From: Don Seltzer <timoneer@gmail.com>
To: Rachel Zsembery <rzsembery@town.arlington.ma.us>, KLau@town.arlington.ma.us, Eugene Benson <EBenson@town.arlington.ma.us>, MTIntocalis@town.arlington.ma.us, Stephen Revilak <srevilak@town.arlington.ma.us>
Cc: Kelly Lynema <KLynema@town.arlington.ma.us>
Date: Sun, 24 Jul 2022 12:42:55 -0400
Subject: Re: Docket #3704, 18-20 Belknap Street - Further Comments

I offer these observations on the issues raised at the July 11 hearing and the applicant's revised plans to address these.

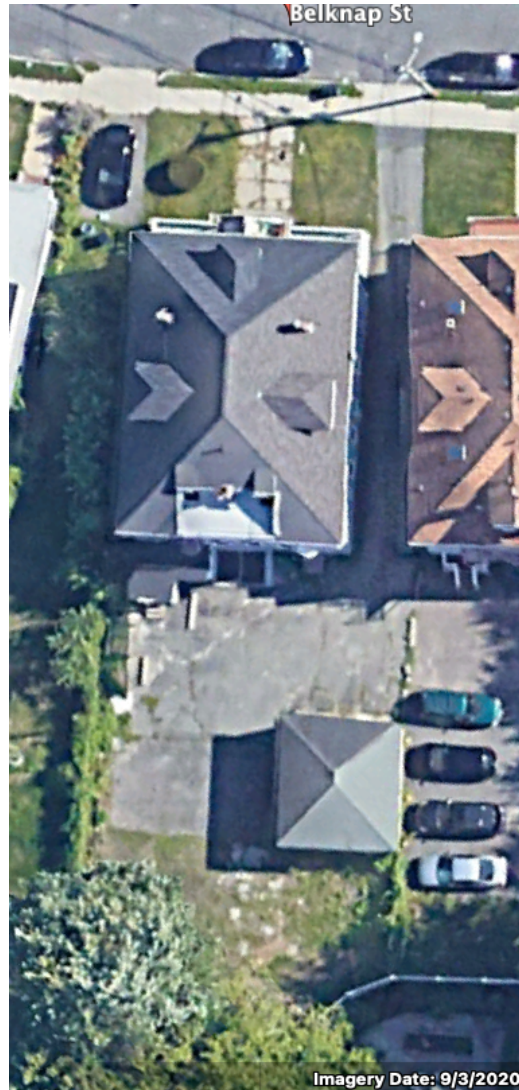
It is also worth noting that the long term prior use of the rear of the lot was as landscaped space qualifying as usable open space. This Google aerial view on Sep 3, 2020 shows that some 1500 sf in the rear of the lot was vegetated and had qualified as existing

open space. It was some time in the following months that the prior owner paved this section over in preparation for the sale to the applicant, without any permits and in violation of the bylaw.
